Access Compliance Report

Public Rights-of-Way

(Curb Ramps)

Intersection ID: 46743	Main Street: SUPERIOR_ST	Cross Street: LAKE_ERIE_LN	Location: NE
ADA ID: 7B59523EE2BC	Ramp Type: Perp	Initial Pass/Fail: Fail	Overall Compliance: No
Severity Score: 22.5			
Codes/Mitigation Info/Possible Solution		Field Measurements/Component Compliance

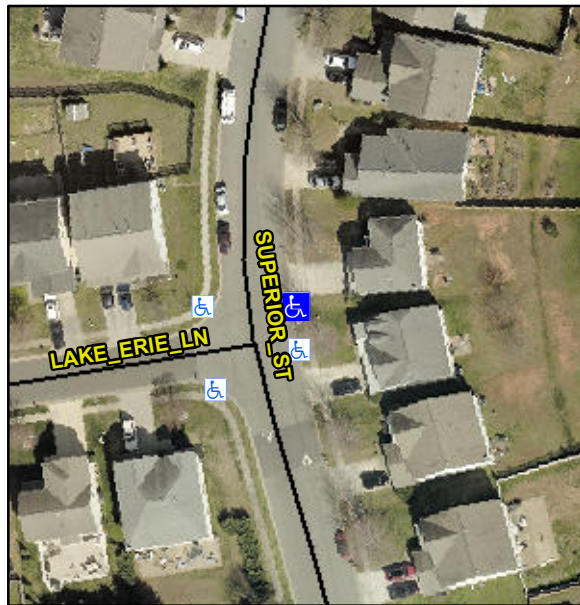
R304.5.1, R304.2.2, R304.5.3

Compliance	Description	Data	Compliance	Description	Data
N/A	Ramp Length (in)	46.0	No	Ramp Slope (%)	10.0
No	Ramp Width (in)	44.0	No	Ramp XSlope (%)	3.1
N/A	Flare Type LT	N/A	N/A	Flare Type RT	N/A
N/A	Flare Slope LT (%)	N/A	N/A	Flare Slope RT (%)	N/A
N/A	Flare Traversable LT?	N/A	N/A	Flare Traversable RT?	N/A
N/A	Landing Length (in)	N/A	N/A	DWS Provided?	N/A
N/A	Landing Width (in)	N/A	N/A	DWS Contrast?	N/A
N/A	Landing Slope (%)	N/A	N/A	DWS Length (in)	N/A
N/A	Landing X Slope (%)	N/A	N/A	DWS Full Width?	N/A
N/A	Landing Curb? (Y/N)	N/A	N/A	DWS Offset (in)	N/A
N/A	Shared Landing?	N/A			
N/A	Gutter Ponding?	N/A	N/A	Gutter Slope (%)	N/A
N/A	Gutter Lip Ht (in)	N/A	N/A	Gutter X Slope (%)	N/A
N/A	Painted X Walk1?	No	N/A	Painted X Walk2?	N/A
	X Walk 1 Direction	To W		X Walk 2 Direction	N/A
N/A	X Walk 1 Width (in)	N/A	N/A	X Walk 2 Width (in)	N/A
	X Walk 1 Slope (%)	3.8		X Walk 2 Slope (%)	N/A
	X Walk 1 X Slope (%)	2.8		X Walk 2 X Slope (%)	N/A

Remove & Replace Entire Ramp.
